World Forum for Harmonization of Vehicle Regulations

Proposal for a Supplement 8 to the 03 series of amendments to UN Regulation No. 79 (Steering equipment)

Submitted by the Working Party on Automated/Autonomous and Connected Vehicles*

“5.6.4.8.2. Detection area on ground level

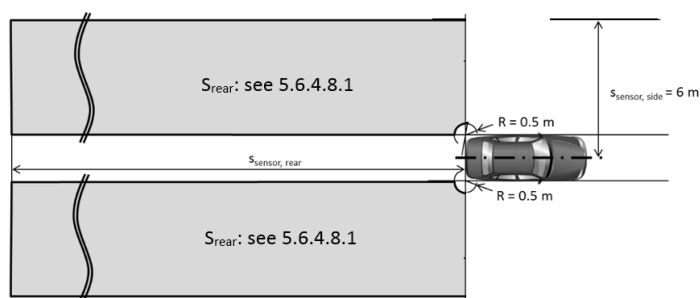
Paragraph 5.6.4.8.2., amend to read:

The vehicle system detection area on ground level shall be at minimum as shown in the figure below.”

2.1.2.1. General

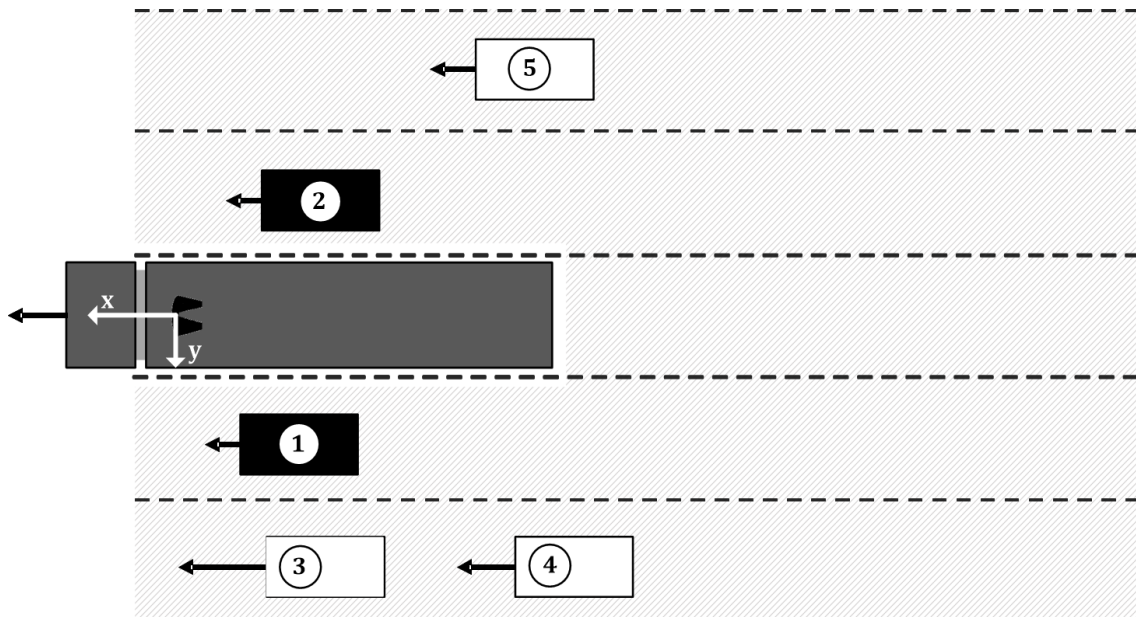
IMPORTANT — If ISO 11992-1 is used as a data link and physical layer only one trailer (towed vehicle) can be supported due to bandwidth overload of the CAN bus between towing and towed vehicles.

The towing vehicle shall not rely on any sorting of the objects communicated by the towed vehicle.

2.1.2.3. Objects behind the towed vehicle

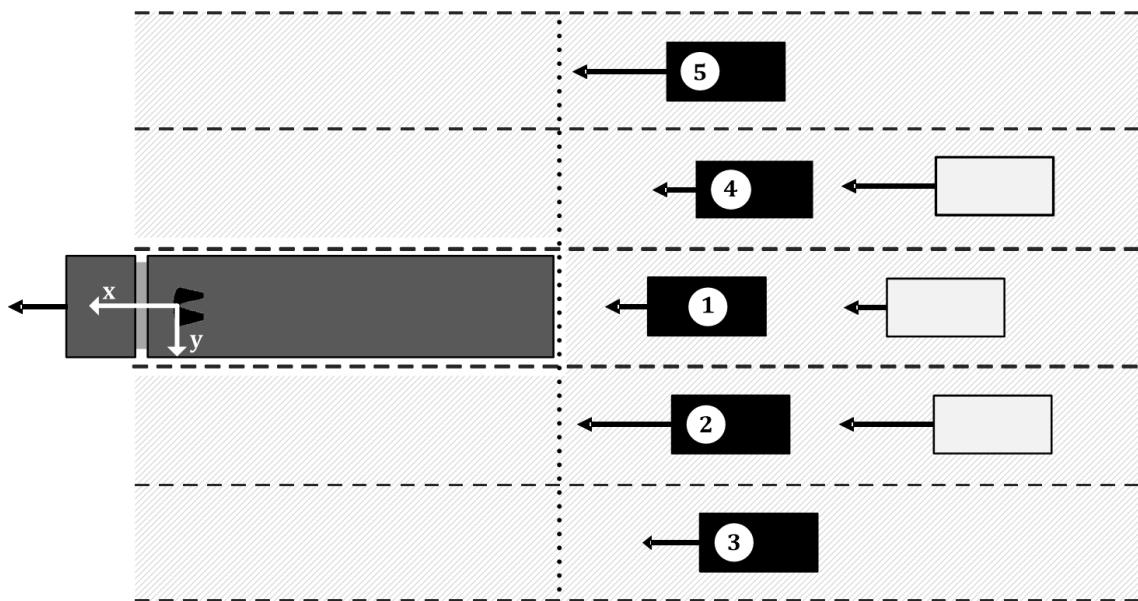
The area behind the towed vehicle is split into five ranges. From each range an object shall be selected, if present. If the absolute velocity of the towed vehicle > 10 km/h only moving objects shall be selected. An object is moving if its absolute velocity is not zero. The five ranges are specified by the lateral position relatively to the towed vehicle:

- (a) $-0.5 \times w - 7 \text{ m} \leq y < -0.5 \times w - 3.5 \text{ m}$
- (b) $-0.5 \times w - 3.5 \text{ m} \leq y < -0.5 \times w$
- (c) behind the towed vehicle
- (d) $0.5 \times w < y \leq 0.5 \times w + 3.5 \text{ m}$
- (e) $0.5 \times w + 3.5 \text{ m} < y \leq 0.5 \times w + 7 \text{ m}$

Where y is the lateral position [m] and w is the width [m] of the towed vehicle.
